Task Force SAFE

Inspection-Report_TFSAFE_Full_ALQ26_SDP-2-E_113_09-06-26_1-8

| Building # | SDP-2-E | System Voltage | 230/400 |

| Deficiency #2 | RAC 2 | Occurrences: 1 |

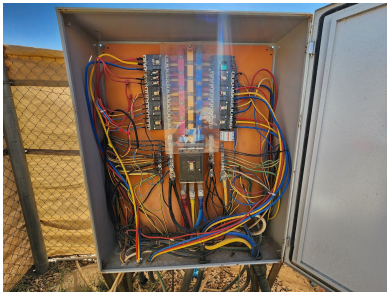
Description: No dead front present within SDP. Access requires a key or a tool.

| Code: | British Standard 132: Protection against electric shock |

| Deficiency #6 | RAC 2 | Occurrences: 2 |

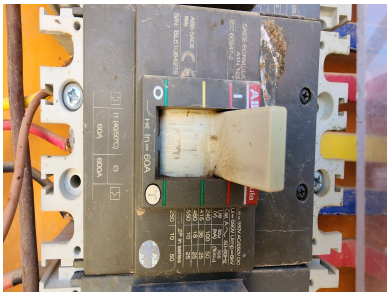
Description: 6mm² and 2.5mm² conductors fed from the same 60A MCCB.

| Location: | Within SDP, circuit 3/TP. |
| Code: | British Standard Appx 4: Current carrying capacities and voltage drop for cables |

| Deficiency #7 | RAC 2 | Occurrences: 1 |

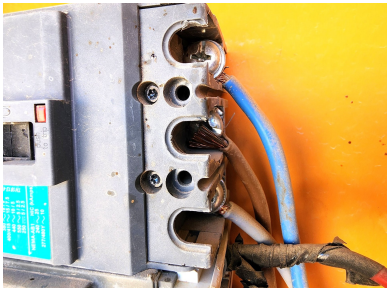
Description: Outgoing conductor L2 is only 50% captured under terminal screw.

| Location: | Within SDP, circuit 6/TP. |
| Code: | British Standard 526: Electrical connections |
